RE: **Patrick Brook / Route 116 Culvert Review – Hinesburg, VT**  
**MMI# 4726-02**

To: Alex Weinhagen, Director of Planning & Zoning  
From: David Saladino, P.E.; Ben Swanson  
Subject: Hannaford Supermarket – Traffic Engineering Peer Review  
Date: 2 July 2013

To: Alex Weinhagen, Director of Planning & Zoning  
From: David Saladino, P.E.; Ben Swanson  
Subject: Hannaford Supermarket – Traffic Engineering Peer Review  
Date: 18 June 2013

## **VT 116/Commerce Street Intersection Truck Turning Templates**

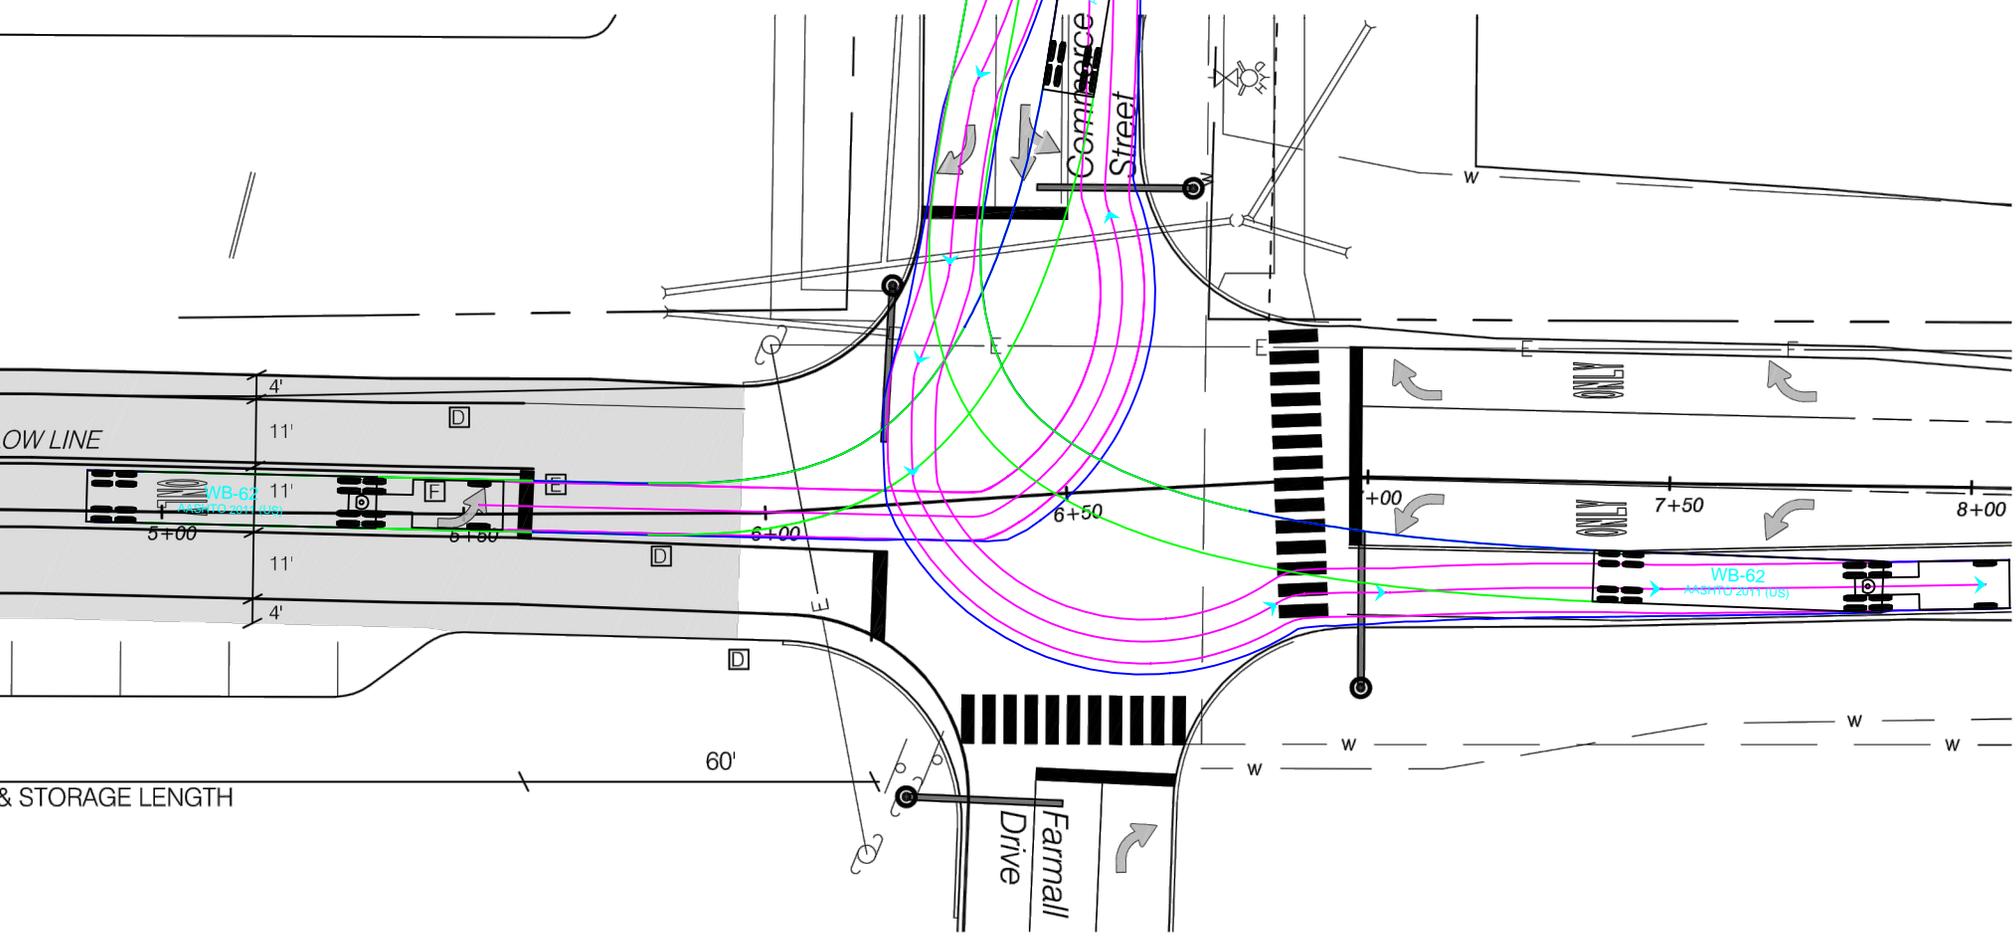
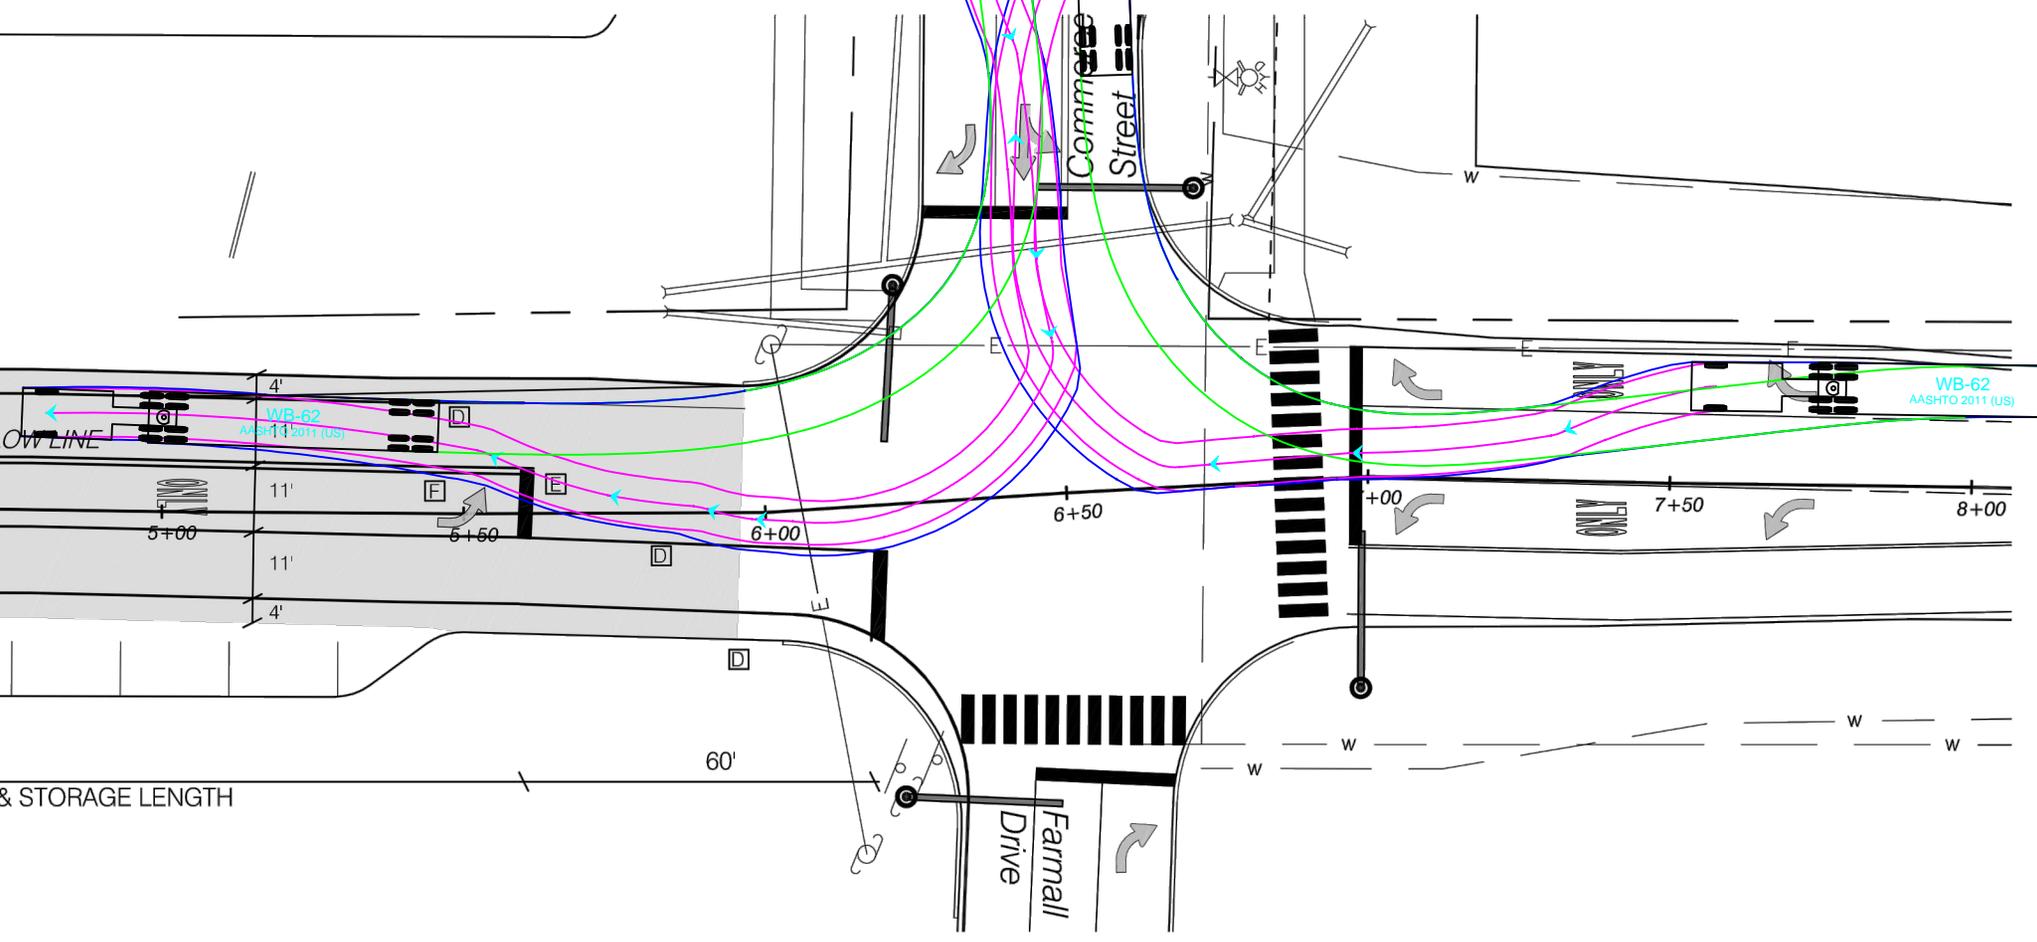
- We have examined truck turning paths entering and exiting Commerce Street at the VT 116/Commerce Street intersection using AutoTurn software to determine potential locations of stop bar conflicts (see Appendix A).
- Based on our analysis, we recommend the following:
  - Relocate the stop bar for the westbound left/through lane from Commerce Street back approximately 25 feet to accommodate southbound left-turn entering trucks.
  - Given the tight curb radius on the southeast corner of the intersection and our analysis showing the need for a northbound right-turning truck to have to encroach significantly into adjacent lanes, we suggest that any large site-generated truck trips arriving from the south be directed to the site via Mechanicsville Road to Commerce Street.

## ESTIMATED MARKET AREA

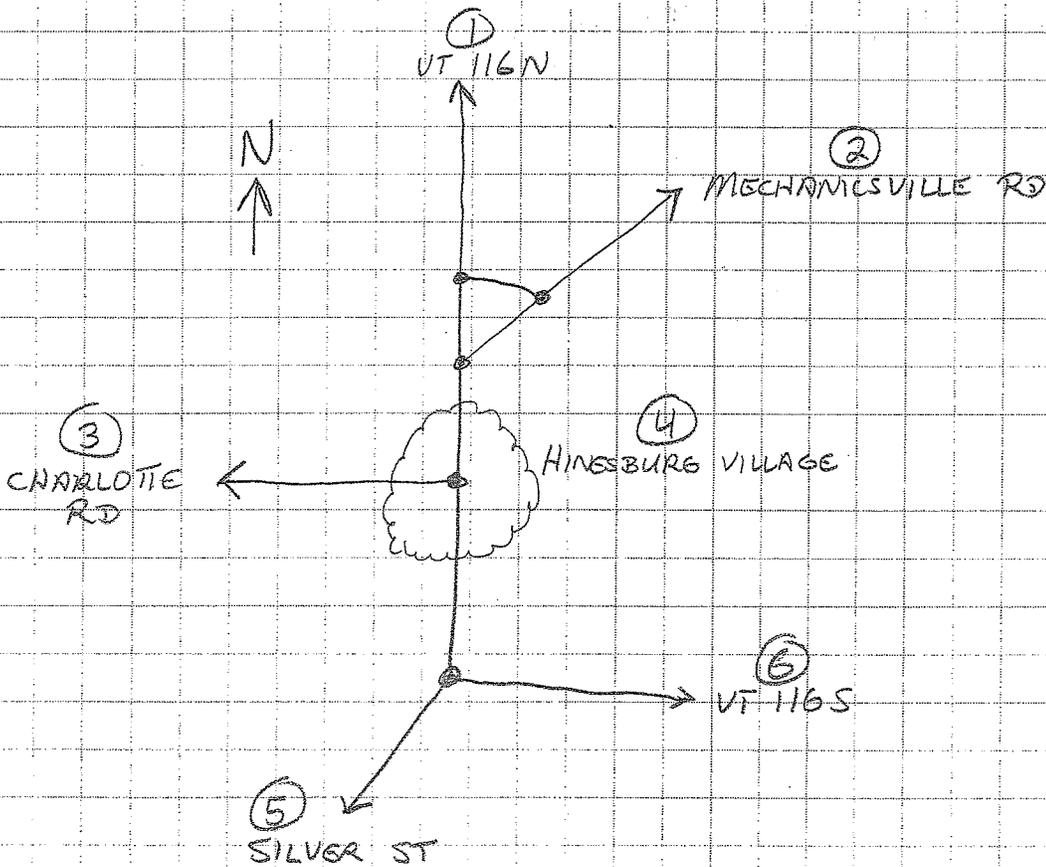
The Hannaford TIA notes that primary trip distribution is based on “the geographic distribution of surrounding population” and that passby trip distribution is based on “existing traffic patterns”. Examination of the TIA appendix does not clearly indicate how the surrounding area population was determined for this distribution.

Additionally, when comparing the TIA distribution to the existing Lantman’s distribution observed in the VTrans turning movement counts at the VT 116/Charlotte Road/Lantman’s intersection, we see that, during the PM peak hour, approximately 77% of the Lantman’s traffic arrives from the north while the Hannaford study has assumed approximately 48% of traffic arrives from the north.

would like to see more information regarding the underlying assumptions used to determine the trip distribution in the TIA, and/or a revised analysis assuming an overall distribution matching the existing Lantman's traffic distribution.

In comparing the two sets of directional patterns, one must take into account the different locations of Hannaford vs. Lantman’s, particularly with respect to trips to/from the northeast via Mechanicsville Rd and to/from the west via Charlotte Rd. With those differences accounted for, the proposed Hannaford directional patterns compare favorably to Lantman’s existing directional patterns.
